# RA8T2 Group

Evaluation Kit for RA8T2 Microcontroller Group  
EK-RA8T2 v1  
Errata

Renesas RA Family  
RA8 Series

Figure 1. PMIC Schematic Connection of ENA, ENB and ENC

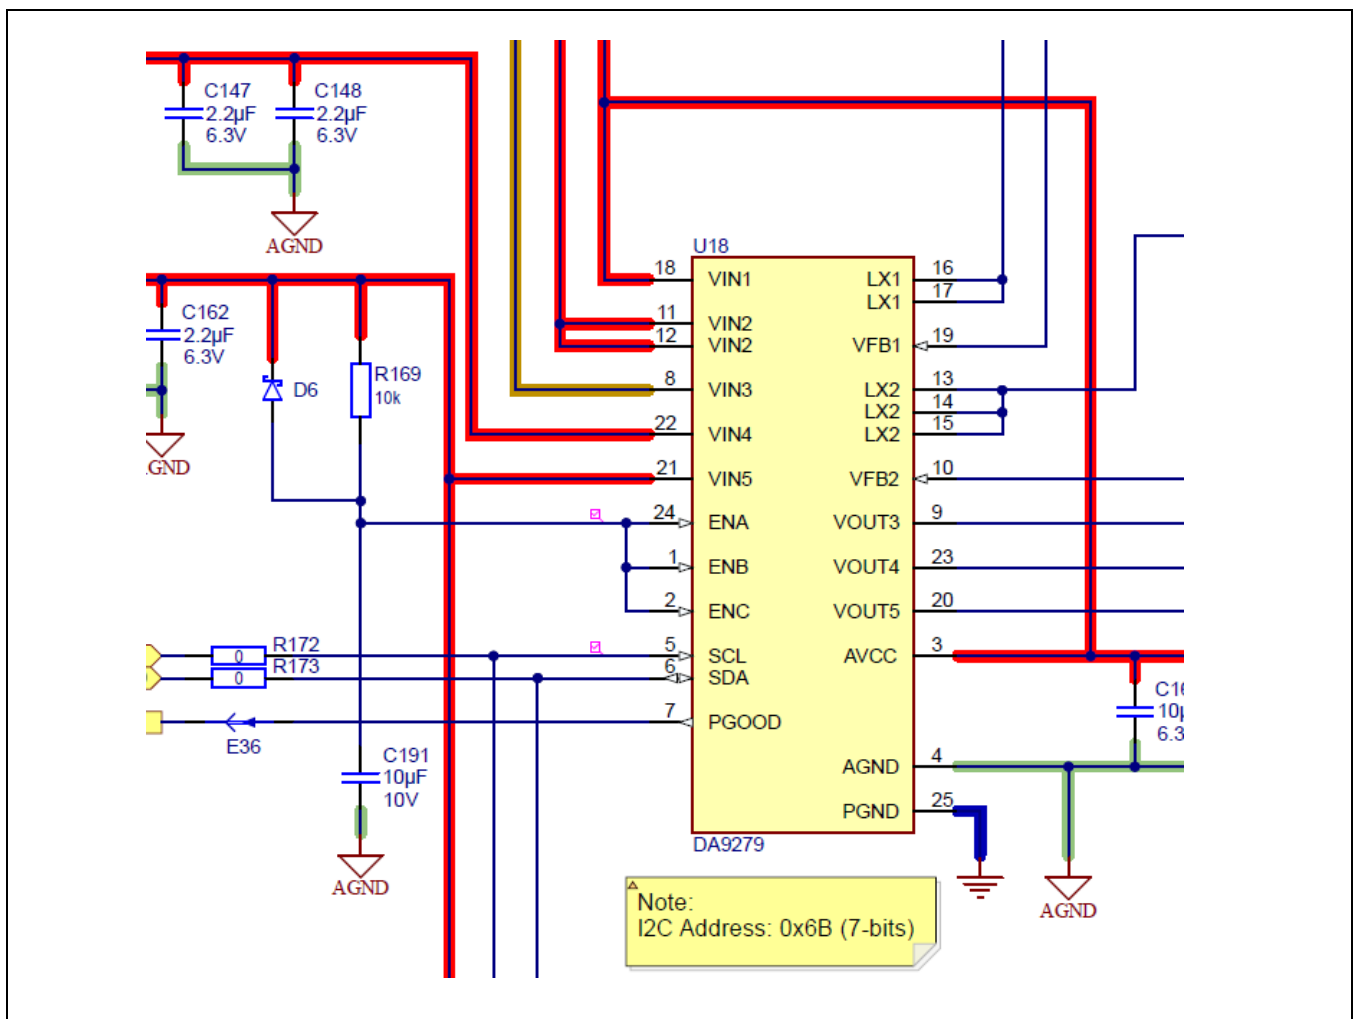
Power to the board is supplied by a DA9279 Power Management IC (PMIC), U7. The data sheet for the DA9279 PMIC specifies that ENA should be enabled first followed by ENB and ENC in any order. However, the three enable pins are connected and so all three are enabled at the same time. The consequence of this is that very occasionally the board does not power up when power is applied.

There is no corrective action. The issue occurs very rarely and is usually remedied by power cycling the board.

This issue will be corrected in later versions of the kit.

Figure 2. Channel 0 Ethernet Connector Schematic

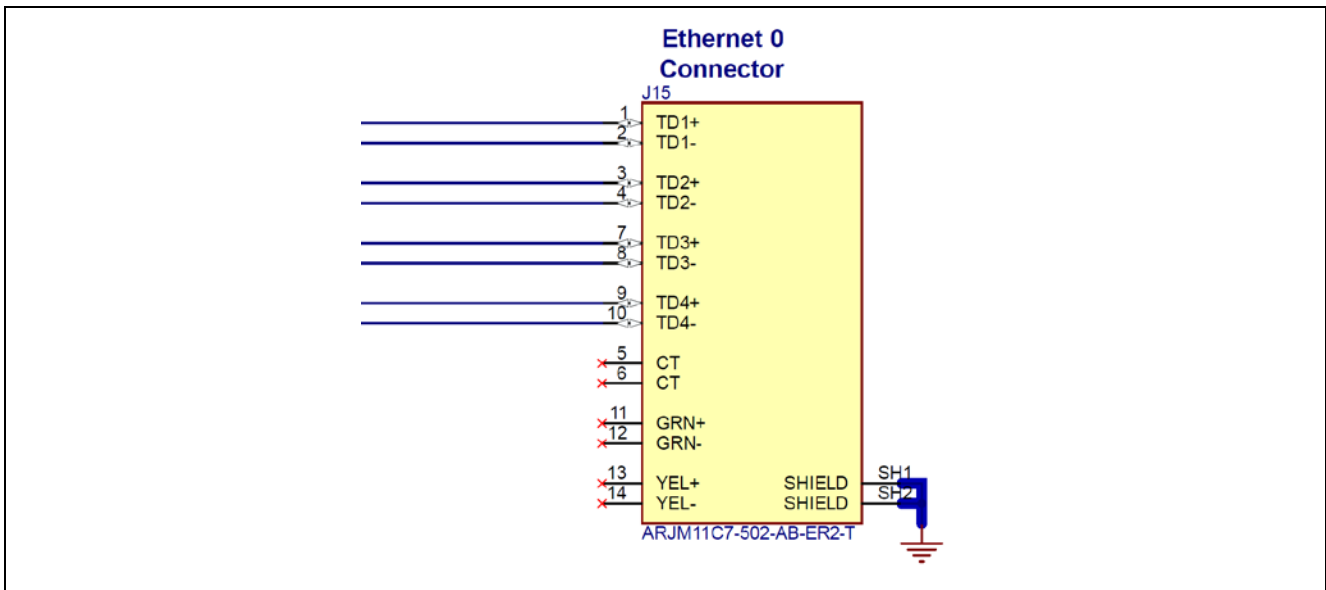
There are no filter capacitors on the CT pins of the Ethernet connectors. This does not normally cause any problems but may affect performance if very long cables are used when connecting to J15 or J34.

To address this, solder 220 nF capacitors (for example GCM155R71C224KE02D) between each of the CT pins and GND on J15 and J34.

Figure 4. Ethernet PHY COMA\_MODE Pin

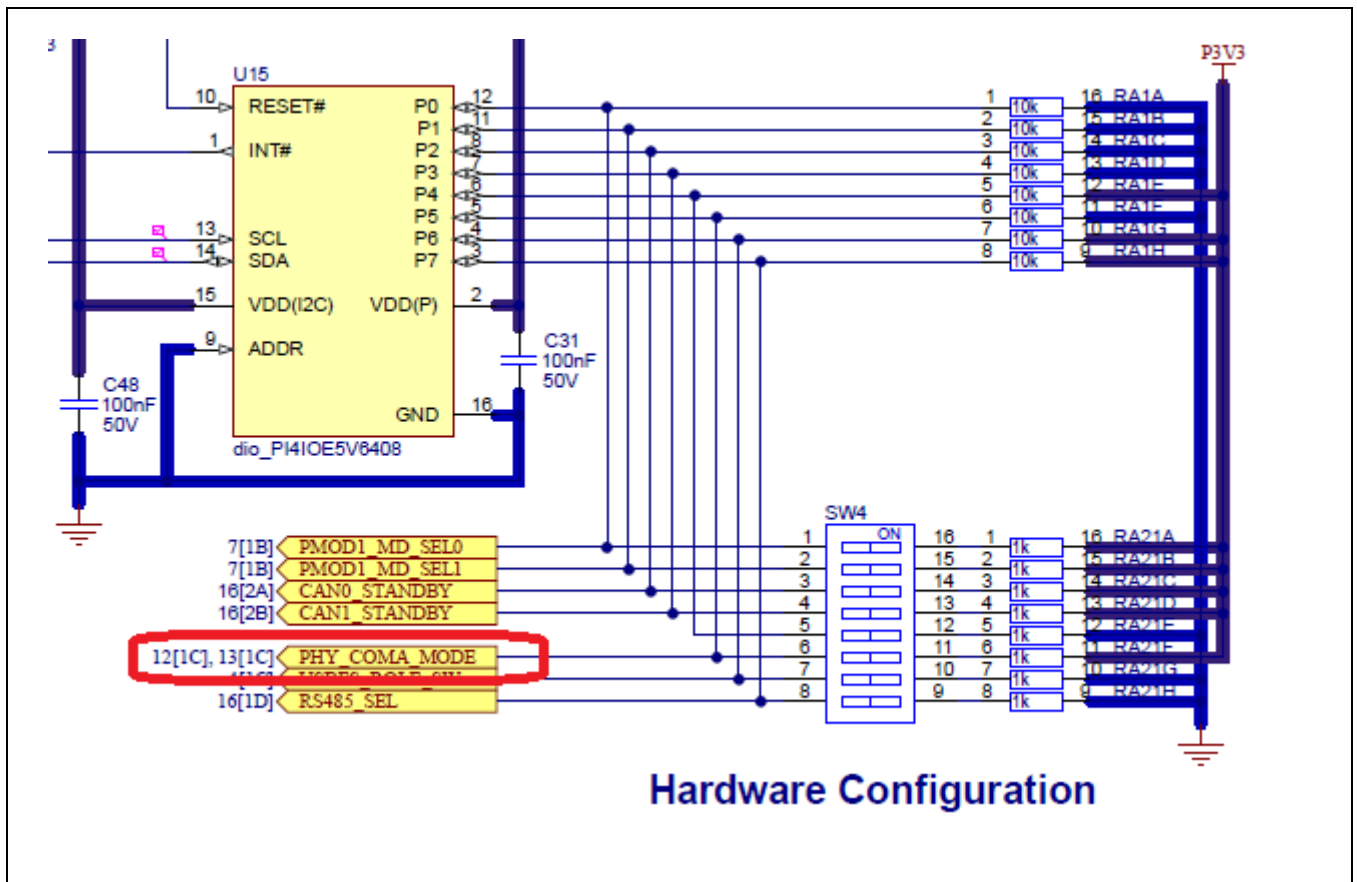
The VSC8541XMV-02 Ethernet PHYs U8 and U12 fitted to the board incorporate an internal pull-up which, in conjunction with the external resistors RA1F and RA21F, prevent the COMA\_MODE signal meeting the required levels to enable and disable the PHY.

The boards have been modified such that a 5k6 resistor pack has been fitted in parallel with RA1 and a 4k7 resistor pack has been fitted in parallel with RA21. This enables the PHYs to be correctly enabled and disabled without affecting operation of the other signals.
